PLANNING COMMISSION

1. Call to Order, Roll Call, & Pledge of Allegiance
2. Public Comment on Non-Agenda Items
3. Public Hearing
 - a. LU-0014-2024 VAR, SDR – Cherry Park East Apartments – **UPDATED STAFF REPORT**
4. Presentation Erika Palmer, Community Development Director & Marlee Boxler, Economic Development Coordinator
 - a. Downtown Parking Study Presentation
5. Staff Communications
6. Commissioner Comments
7. Adjournment

SITE PLAN
1360 SW 257TH AVE
TROUTDALE OR 97060

FILE NUMBER / NAME	LU-0014-2024 Cherry Park East Luxury Apartments		
APPLICATION TYPE	Type III Variance, Site Development Review		
PROJECT APPLICANT	Tracy Brown	PROPERTY OWNER	Mike Halstead
PROJECT LOCATION	1360 SW 257th Ave	TAX MAP / TAX LOT #	1N3E35AA -05717
COMPREHENSIVE PLAN DESIGNATION	High Density Residential	LAND USE ACTIVITY	Multi-Family Development
ZONING DISTRICT	HDR - High Density Residential	OVERLAY DISTRICT	None

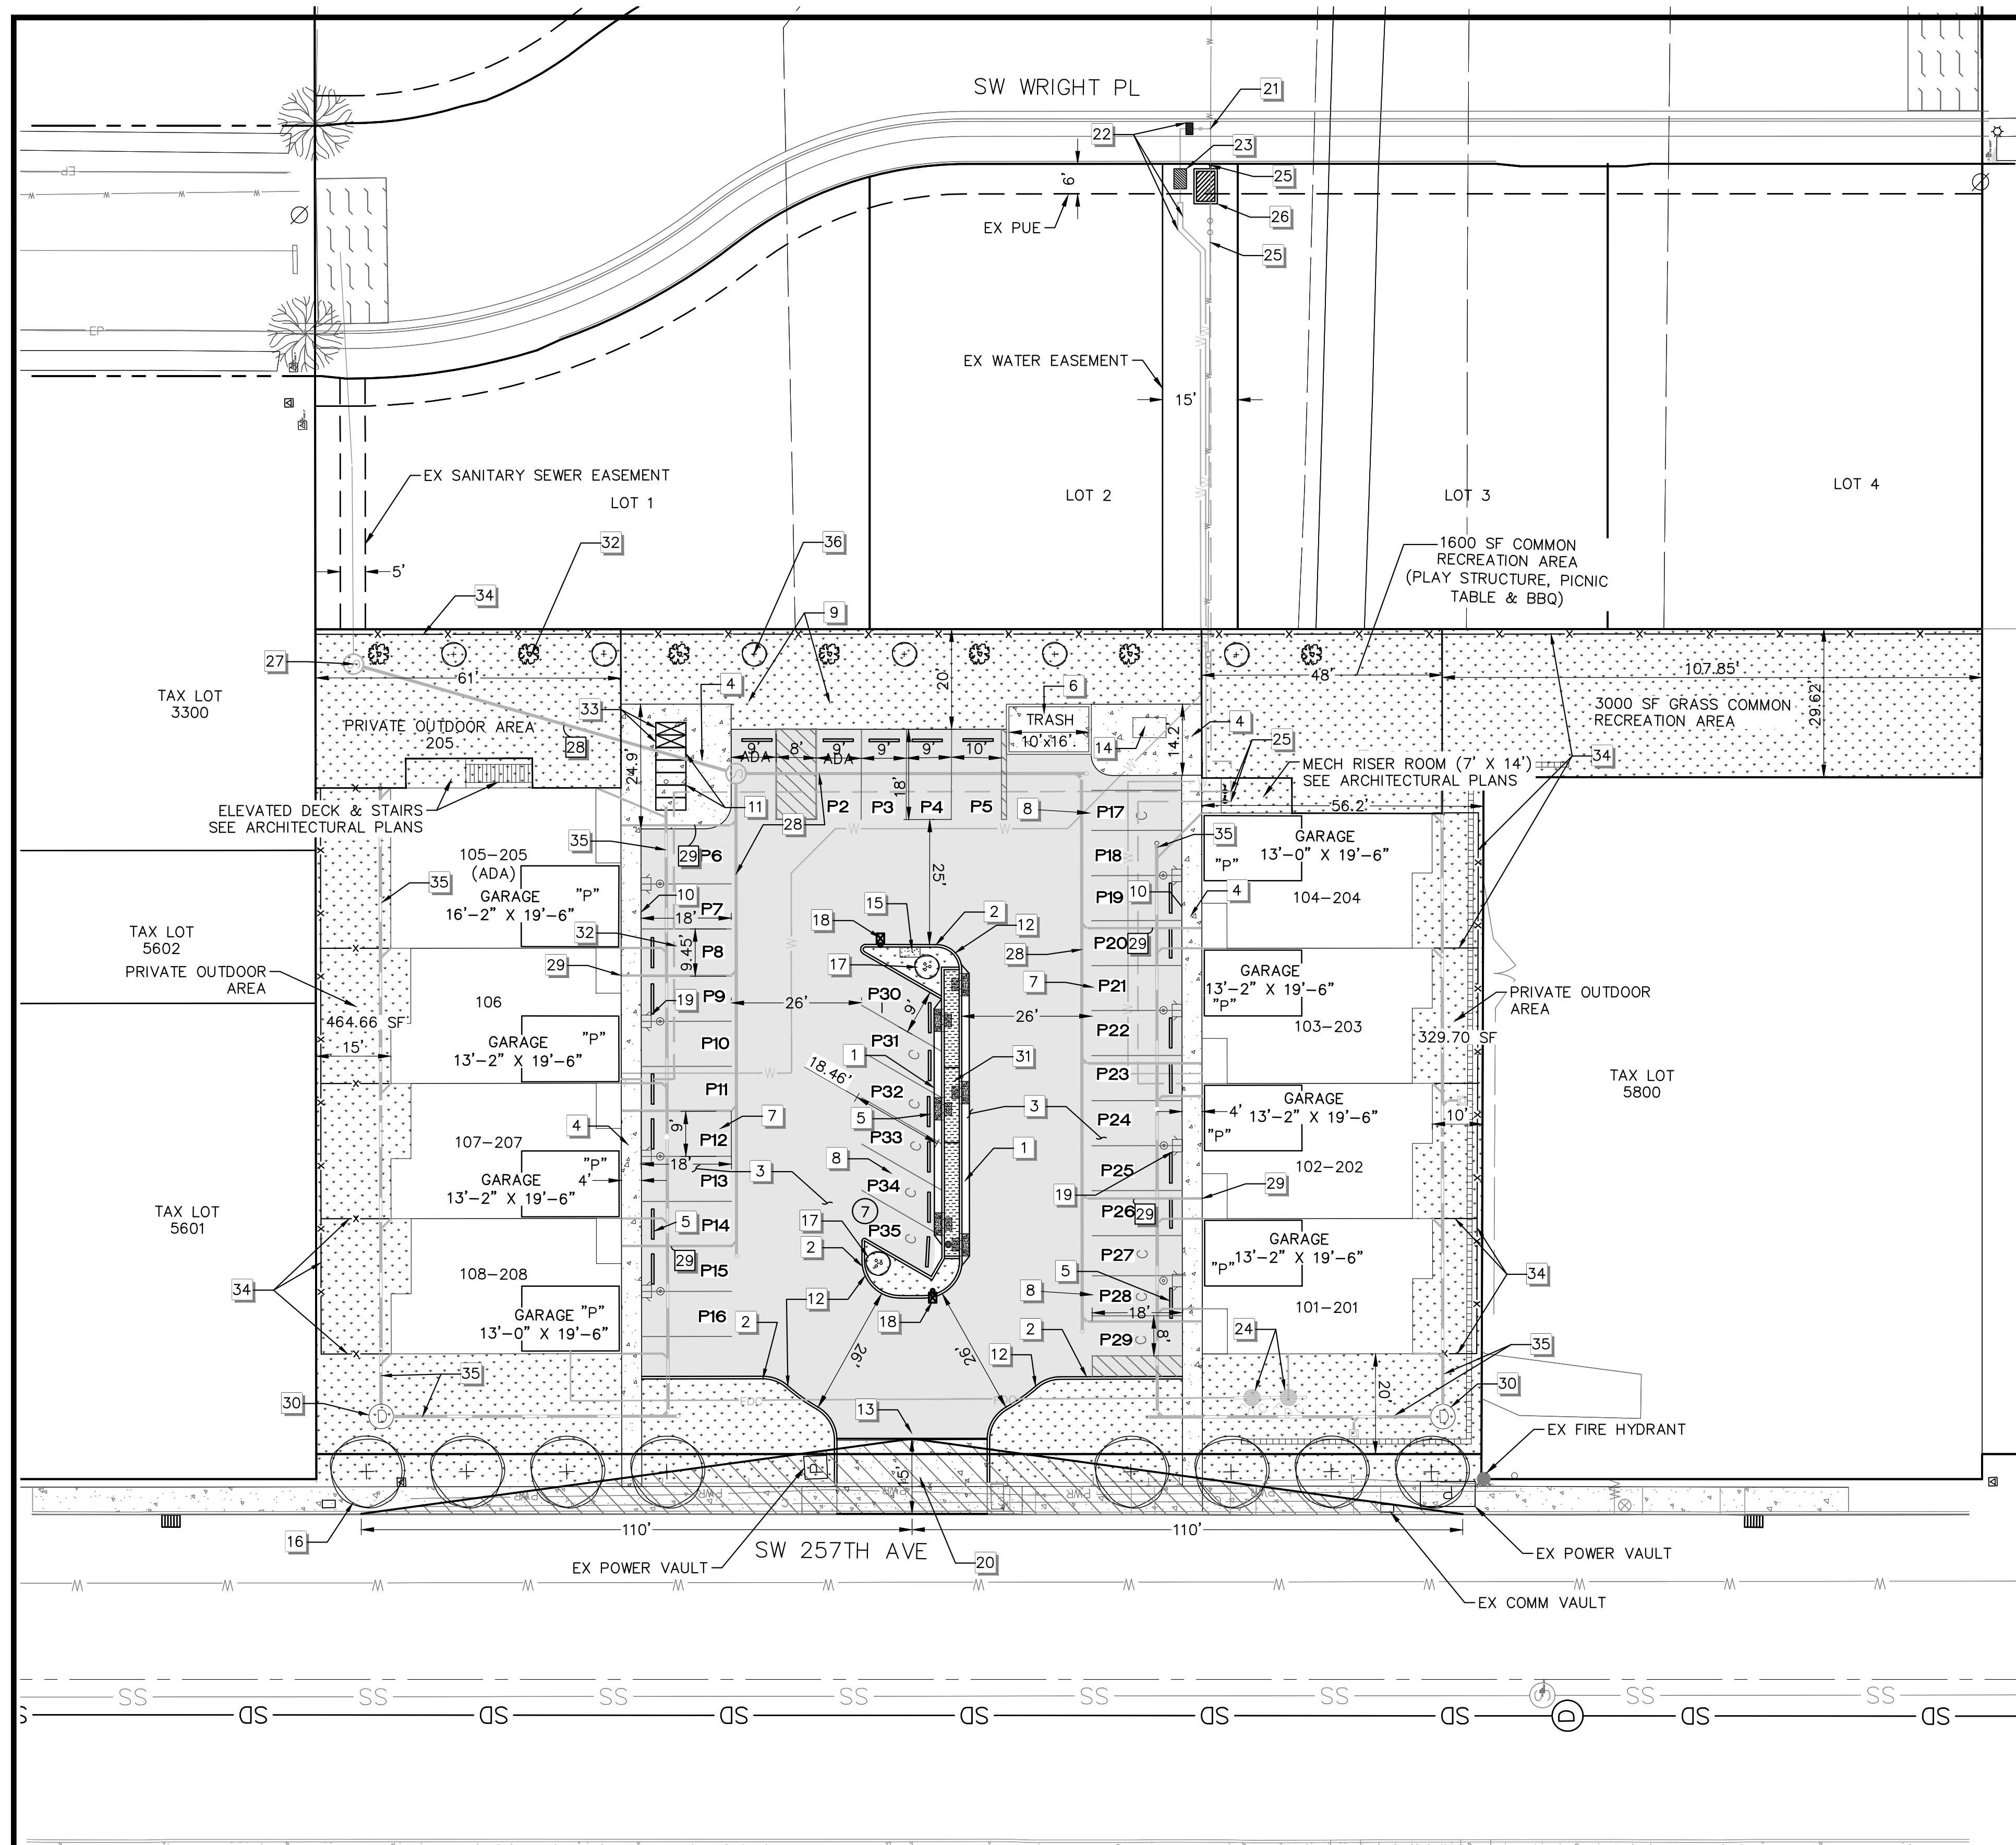
11. If a gate is installed on a fire access road, it must meet the requirements of the Gresham Fire Gate Policy. **OFC 506.1**
12. Fire access roads exceeding 150' require an approved turnaround. Per the site plan, It appears that this fire access road measures at 150 feet and would not require a turn-a-round. **OFC, Appendix D, Section D103.+**

Finding 23: The site plan shows a 10x16 sq ft trash and recycling enclosure that is constructed with wood fencing and a latching gate. The applicant's narrative and plans do not include details regarding the height of the fence. Per the above provision, the height of the garbage and recycling enclosure shall be six feet in height. **As such, this criterion can be conditionally met.**

Finding 47: The submitted plans show the upper level units having 42 square feet of private outdoor space. The applicant has requested a variance a part of their application to reduce the requirement of upper level required outdoor space to 42 square feet. **As such, this criterion can be met upon variance approval.**

Finding 58: The submitted plans currently show a vehicle charging station that can accommodate 2 vehicle spaces (4% of total parking) which does not meet the above requirement. At the time of building permit submittal, the applicant shall indicate that 40% of all vehicle parking spaces can comply with electrical service capacity for electric vehicle charging, as defined in ORS 455.417. **As such, this criterion can be conditionally met.**

Finding 60: The parking area contains no bays with more than 20 parking spaces. The proposed parking area contains the above required planters for the middle parking island. The parking located on the north, south, and east are surrounded by landscaping. The applicant shall submit a landscaping plan at the time of building permit submittal to confirm the proposed tree species is compliant with this code. **As such, this criterion can be conditionally met.**

Finding 61: The applicant's plans show that all parking area setbacks are landscaped however the majority of the plan does not indicate which types of trees, shrubs, or ground cover are to be used. The applicant shall submit a planting schedule at the time of building permit submittal. **As such, this criterion can be conditionally met.**

3. Per 8.060(A)(6) and (7), a landscaping plan shall be required at the time of building permit submittal.
4. Per TDC section 8.060(B)(1) further detail is needed regarding the garbage and recycling enclosure at the time of building permit submittal. Specifically, the applicant needs to specify the height of the fence surrounding the enclosure.

9. The turning radius for all emergency apparatus roads shall be: 28' inside and 48' outside radius. **OFC 503.2.4**
10. "No Parking Fire Lane" signage or curb marking will be required. Fire access roads 20' – 26' wide require the marking on both sides. Indicate on the building permit plans. **OFC D 103.6**
